CNL-21-020

November 5, 2021

Subject: **Browns Ferry Nuclear Plant, Units 1, 2, and 3 - Application Requesting NRC Prior Approval of a Proposed Chilled-Water Cross-tie Modification to Support System Operability (BFN-TS-518)**

Browns Ferry Nuclear Plant (BFN), Units 1, 2, and 3 - Application Requesting NRC Prior Approval of a Proposed Chilled-Water Cross-tie Modification to Support System Operability (BFN-TS-518)

Figure 1 BFN Control Bay Cooling Supply Configurations

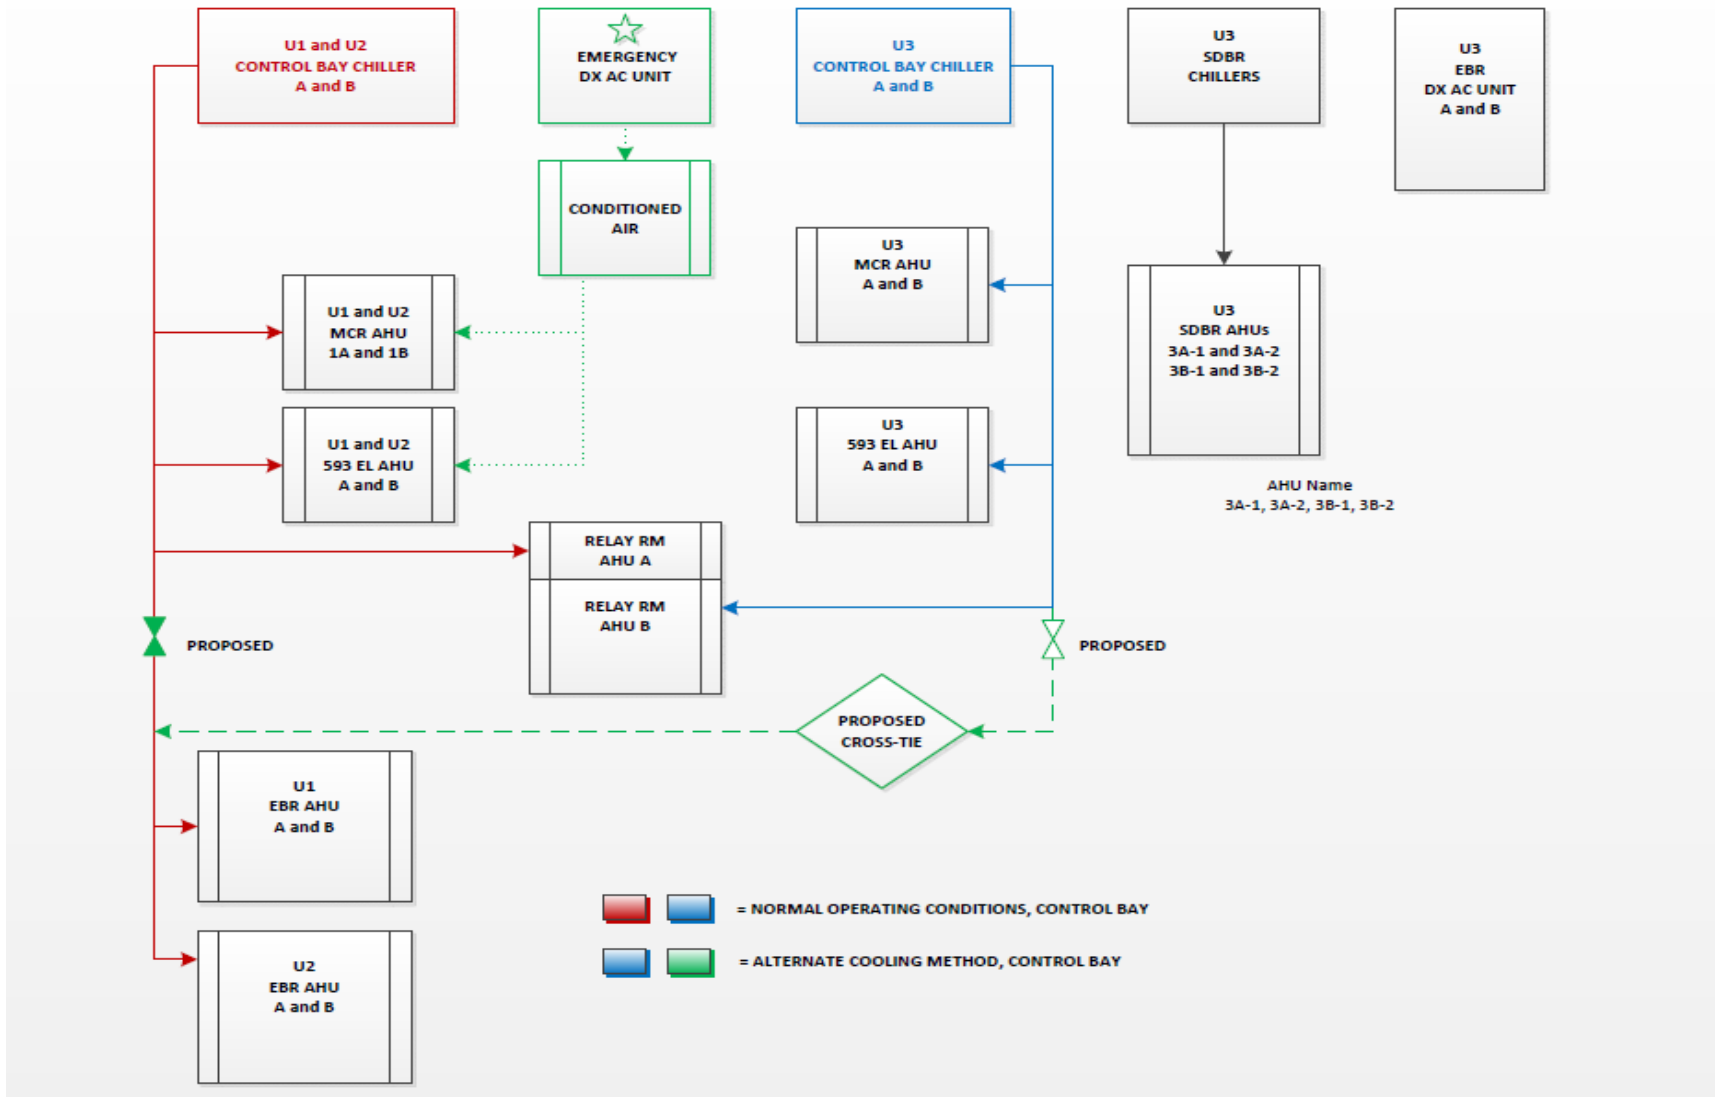
TVA proposes to install a manually operated chilled water cross-tie line from the Unit 3 CB chilled water system to the Unit 1/2 CB chilled water system to be used in the event of an abnormal condition when both trains of the Unit 1/2 CB chilled water system are inoperable. This cross-tie line will meet the same seismic requirements as the current chilled water system piping, which is Class I seismic where appropriate. Operation of this cross-tie line will be performed by operations personnel when the Unit 1/2 CB chilled water system is inoperable (i.e., not providing sufficient chilled cooling water for its equipment loads). A simplified drawing of the proposed modification is provided in Figure 1.

When the cross-tie is in use, the Unit 3 CB chilled water system will supply the Unit 1 and Unit 2 EBR AHUs in addition to its normal loads. Note that, as shown in Figure 1, the Unit 3 4kV and 480V shutdown board rooms are independently cooled by their own chilled-water or air conditioning system. The other Unit 1 and Unit 2 loads not served by the cross-tie, excluding the common switchyard relay room, which is already served by the Unit 3 CB chilled water system, are supplied by emergency direct expansion units when the Unit 1/2 CB chilled water system is unavailable. The emergency direct expansion units have a safety-related power source, are seismically-qualified, and have periodic preventive maintenance performed to maintain functionality.
